**THE ILLINOIS STATE TOLL HIGHWAY AUTHORITY**

**February 13, 2020**

**DESIGN BULLETIN No. 20-02**

**SUBJECT: Noise Abatement Wall, Parapet, and Concrete Barrier Mounted Sign Supports**

STANDARD F11-06

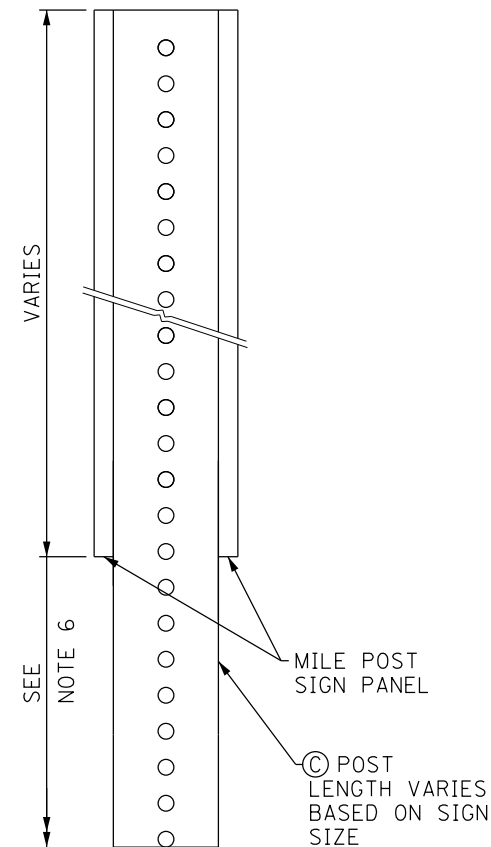
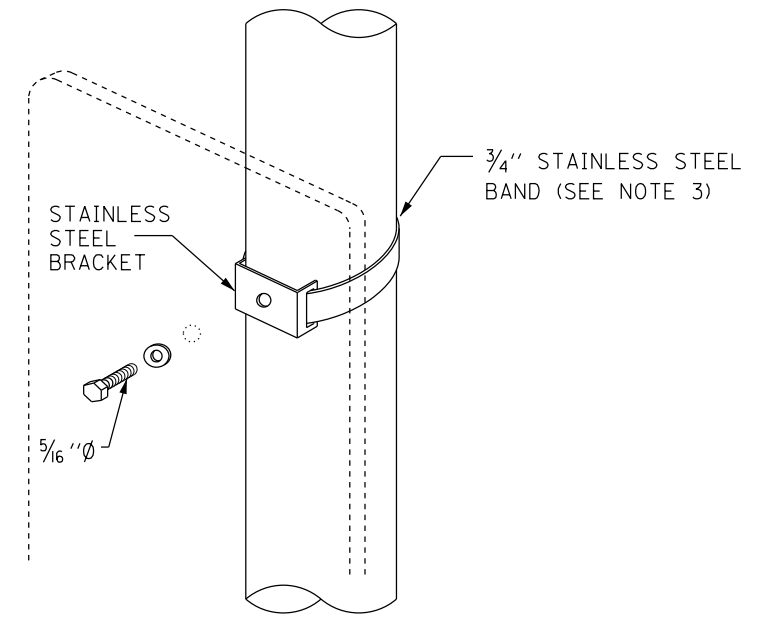
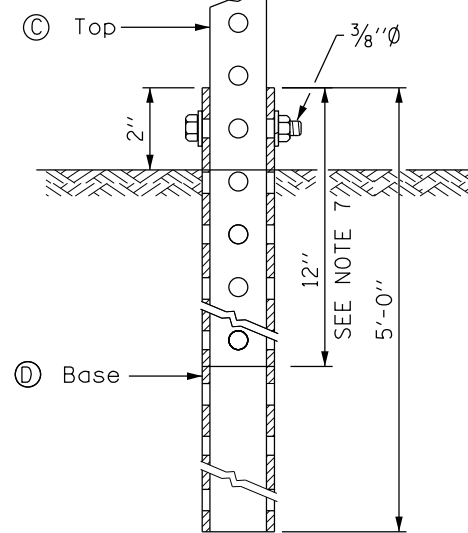
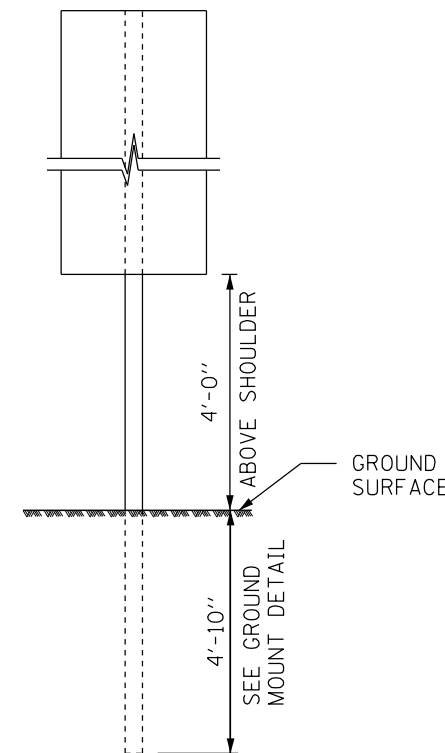
**Milepost Marker:** The existing milepost marker assembly had some premature failures in the welds. Sign Standard F11 has been revised to strengthen the connection of the post to the base utilizing T-fittings in addition to the welded joint.

DATE	REVISIONS
5-8-2009	POSITIONING DETAILS
8-1-2009	REVISED BARRIER WALL MOUNT
3-1-2013	REMOVED MILE POST SIGNS
3-31-2016	REVISED BOLT NOTE
3-01-2019	REMOVED "LIGHT POLE/SIGN STRUCTURE MOUNT DETAIL"
2-13-2020	REVISED BARRIER MOUNT DETAIL AND GENERAL NOTES, ADDED MILEPOST HEIGHT FROM THE EDGE OF SHOULDER

**PARAPET MOUNTED SIGN**  
(MAXIMUM SIGN AREA 20 SF)

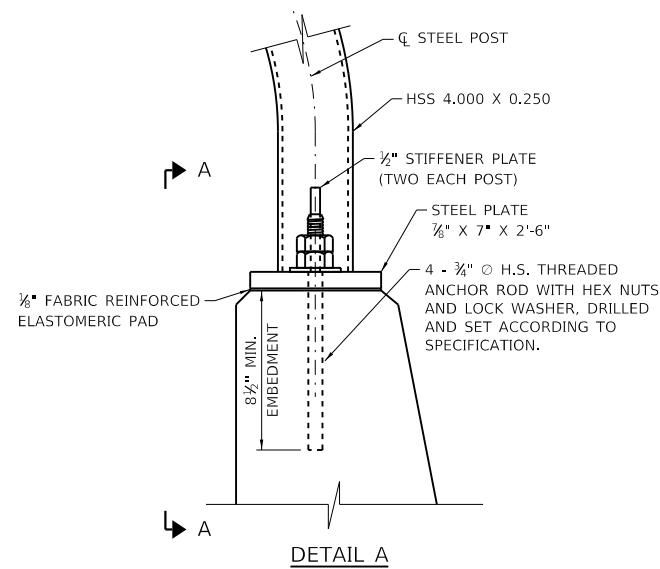
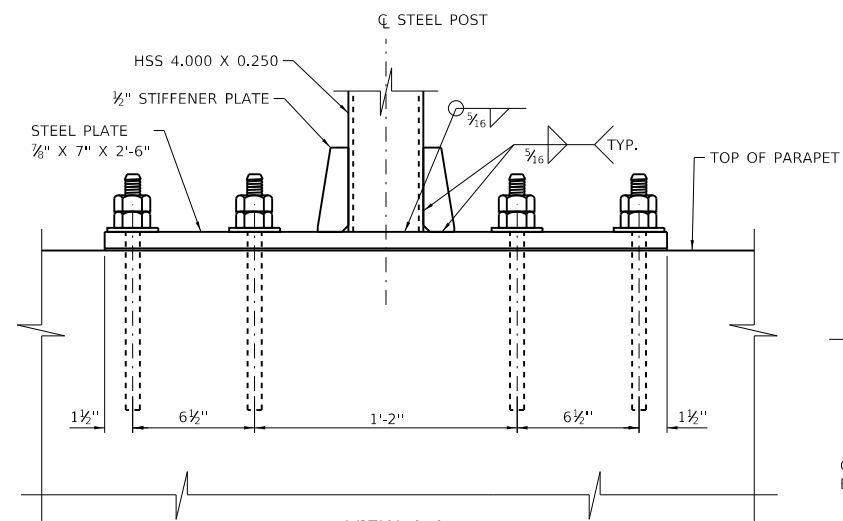
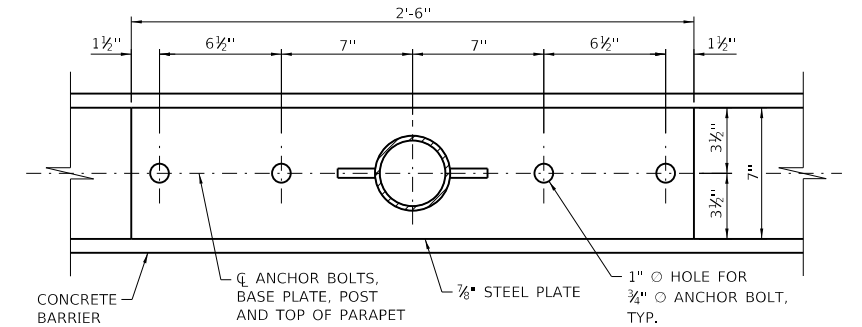
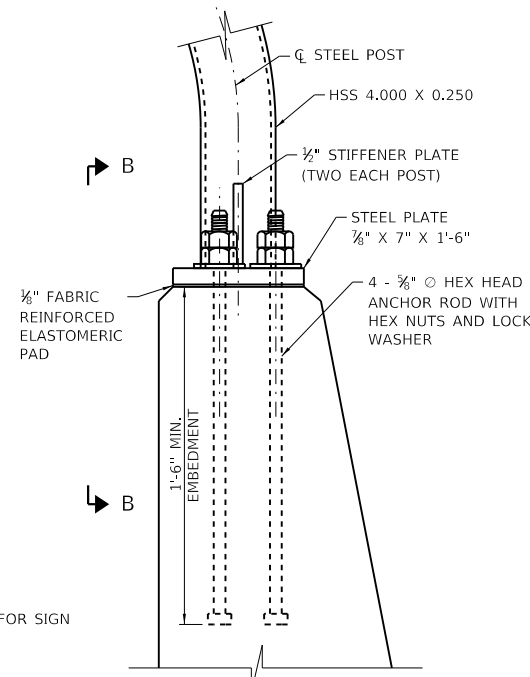
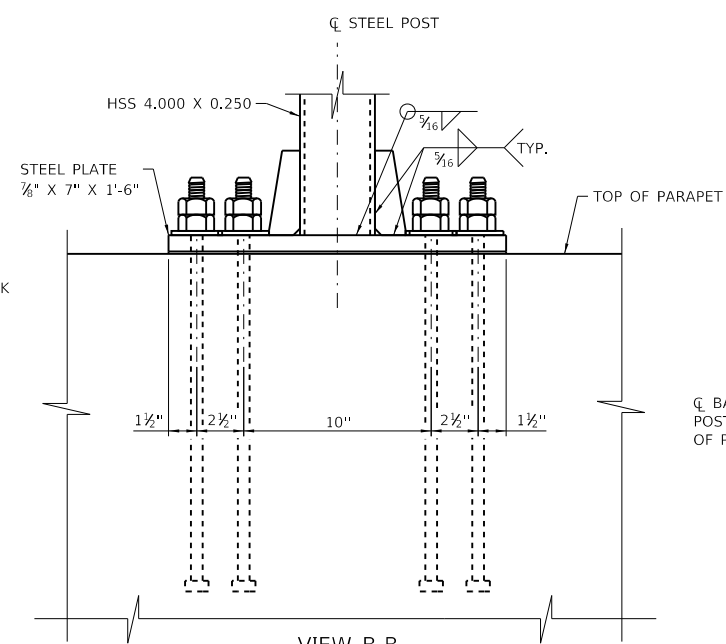
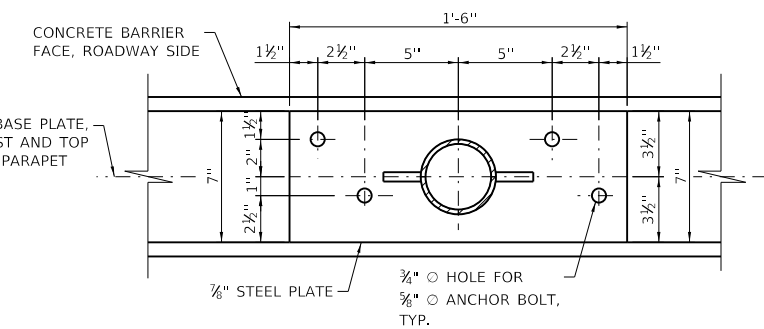
**Parapet Mounted Sign Support:** At various bridge and retaining wall locations there is no space to mount required regulatory and warning signage without the sign overhanging the roadway. The sign mount detail utilized on previous Illinois Tollway projects had the mount attached to the back of the barrier which has been found to be undesirable due to accessibility issues for maintenance. The new design mitigates those accessibility concerns.

NOISE ABATEMENT WALL MOUNTED SIGN SUPPORT

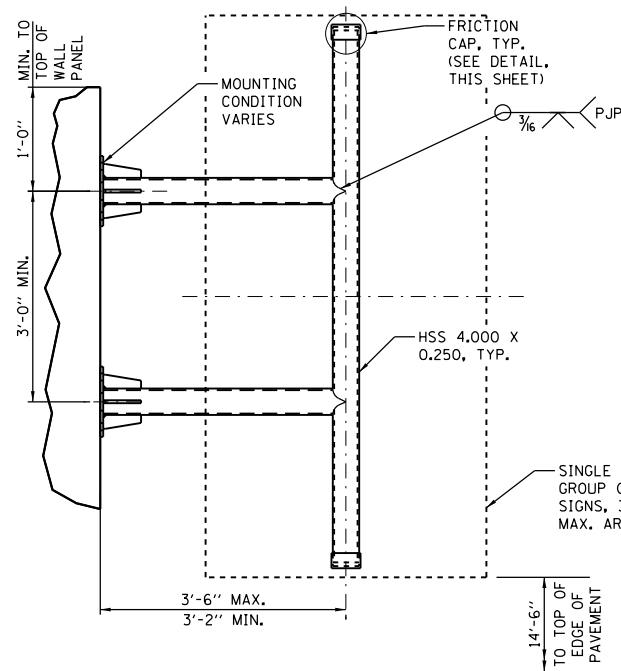
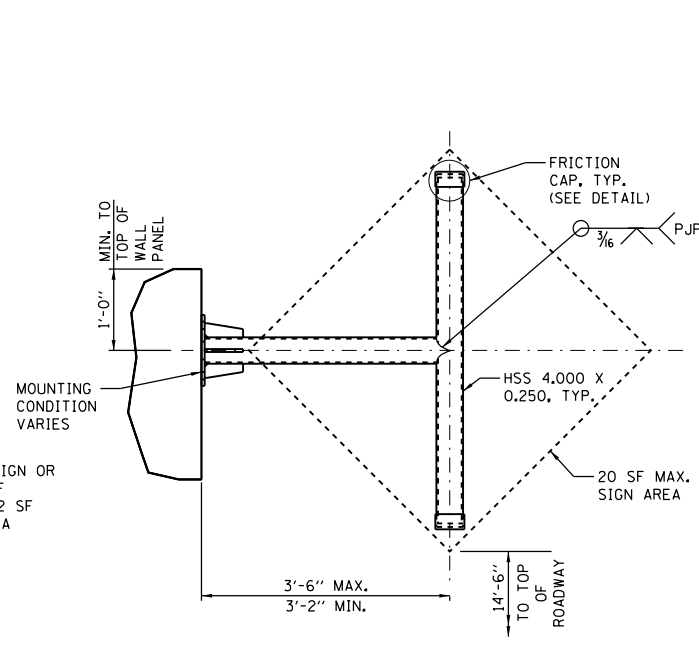
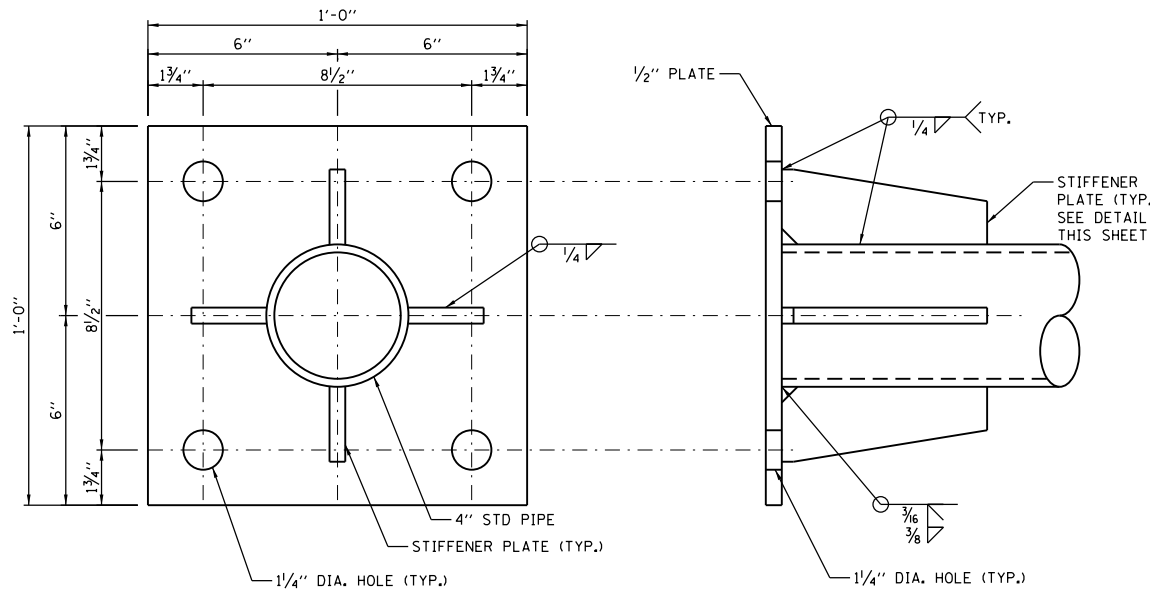
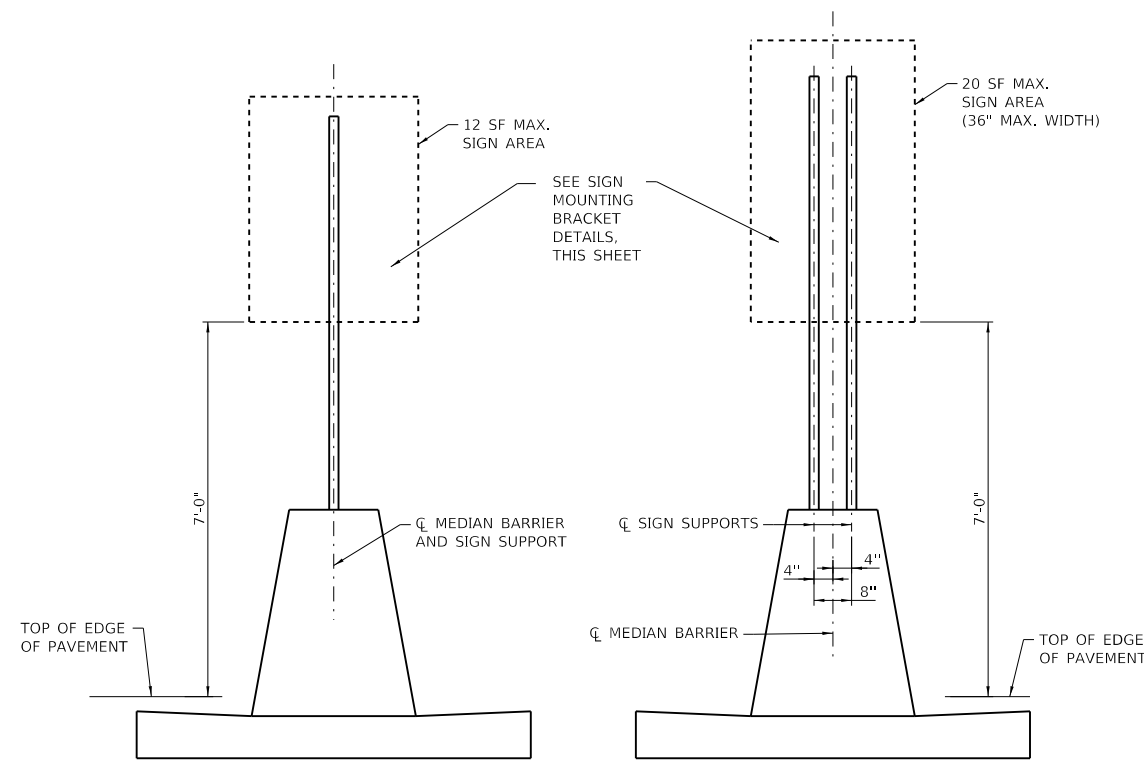
**Noise Abatement Wall (NAW) Mounted Sign Support:** The 2019 Structure Design Manual specifies a minimum NAW offset of 29" from the front face of NAW to the toe of barrier. The specified 29" offset creates insufficient space to install roadway signs between the roadway and NAW. The 2019 Roadway Signing and Pavement Marking Guidelines Section 2.15 has been updated to allow mounting signs to new NAWs provided that the NAW designs account for the signs and mounting heights. The mounting heights shall be a minimum of 14'-6" above the roadway level. Where the mounting is above the NAW height, the sign support bracket shall be mounted on the NAW posts.

MEDIAN BARRIER MOUNTED SIGN SUPPORT

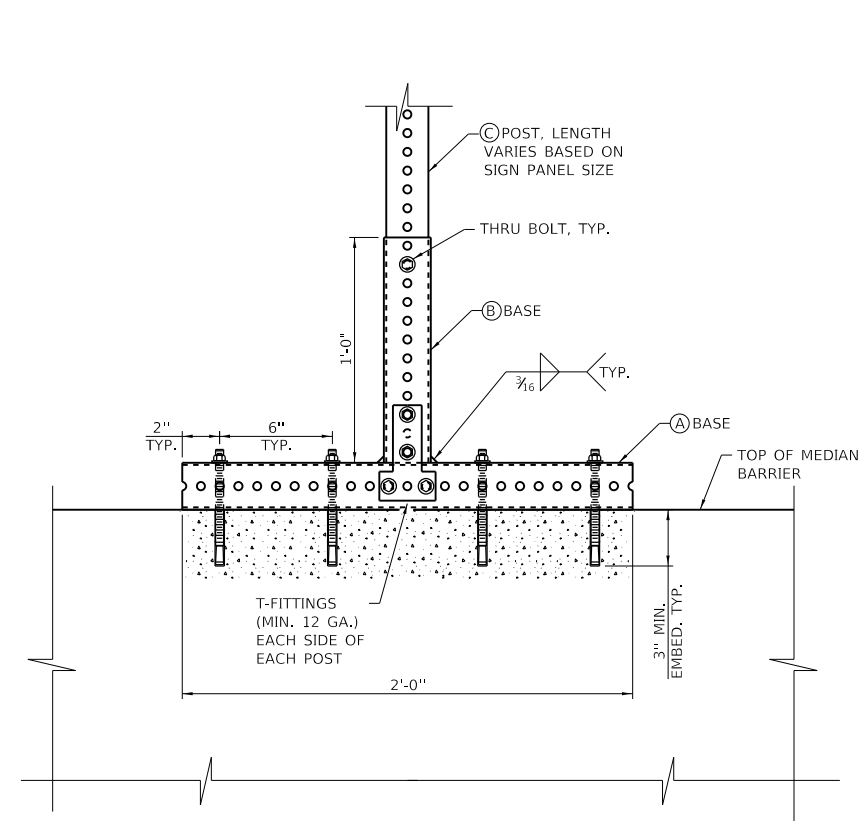
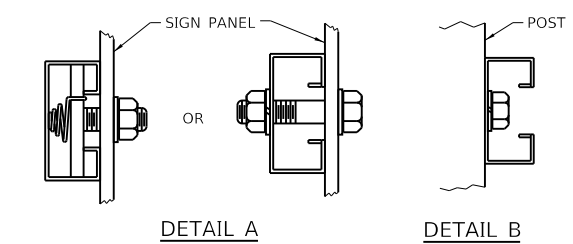
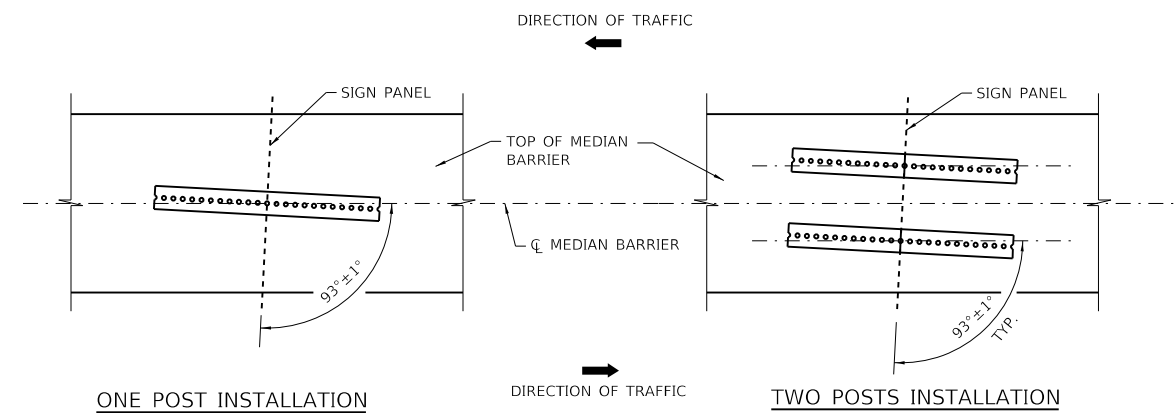
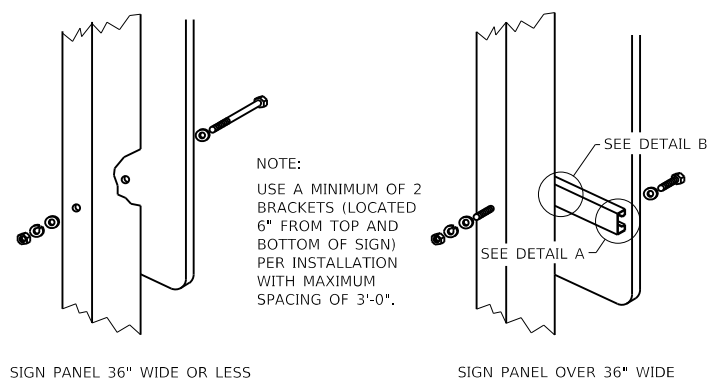
**Median Barrier Mounted Sign Support:** There is currently no separate standard for the median barrier mounted signs. In the absence of the standard, Design Section Engineers (DSE) utilized the milepost marker support to install the sign panels which had a larger sign area than its capacity. A new standard has been developed utilizing telespar posts for the sign post for sign areas up to 20 SF.
